SERVICE BULLETIN

PRODUCT UPDATE: MUFFLER, HEAT SHIELD

All F16 go-karts equipped with Muffler Heat Shield [7]

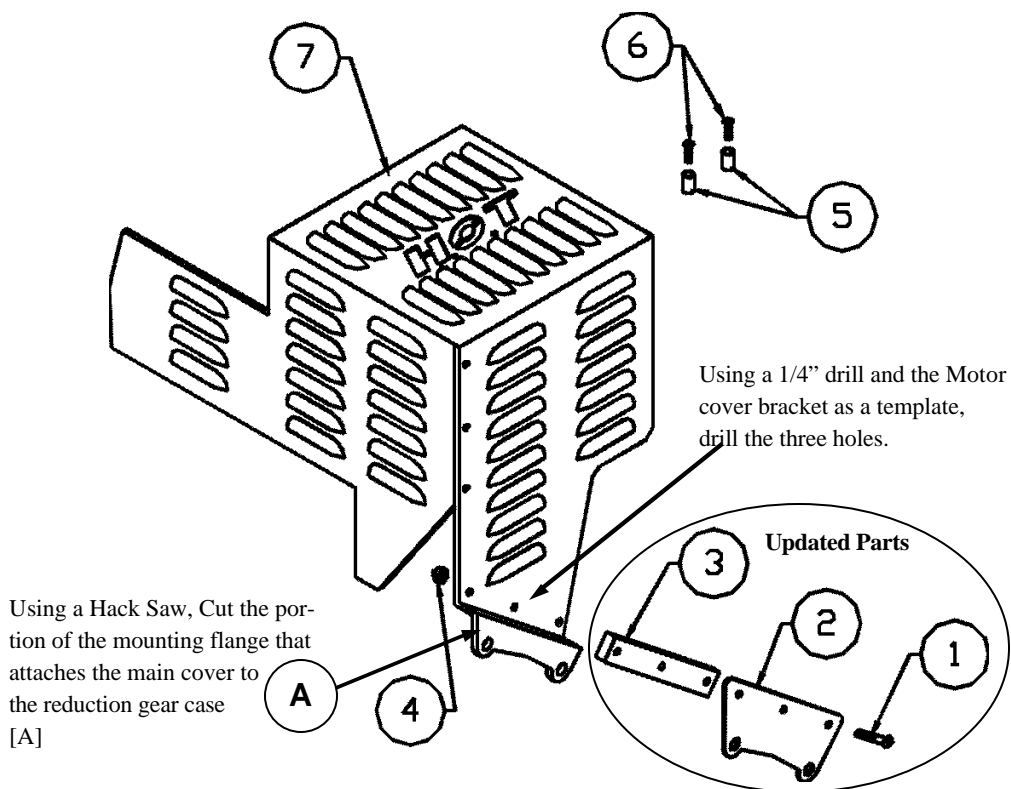
The Muffler Heat Shield breaks where it attaches to reduction gear case. (see reference [A])

Install Update immediately.
